U.S. Bus Corporation has determined that a defect exists in several buses manufactured by our company, and has initiated a recall of affected vehicles.

Subject: Defect Information Report relating to certain model stop arms shipped to U.S. Bus Corporation between January 1, 2002 and March 1, 2005.

NHTSA Campaign Number: 05E-032

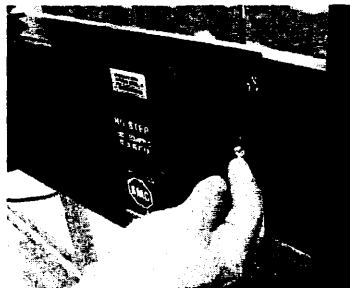
15. Heater inspection and electrical connection-
In order for the new switches to operate properly, the heater must be wired to a 12v source that is controlled by the ignition switch. Inspect bus heater wiring to verify. If heater is not connected to the ignition circuit, there are two possible wiring configurations to achieve this:

- a) on full size buses, route the yellow wire from the heater into the electrical access panel located just in front of the stop arm. In this panel connect the heater to a switched electrical circuit such as "IGNITION ASSY"
- b) On "cutaway" buses, use the snap connector included with the switch kit to connect the yellow wire from the heater to the double red wire in the stop arm. After doing this, the red wire (12v+) coming into the stop must be reconnected to a switched ignition source.
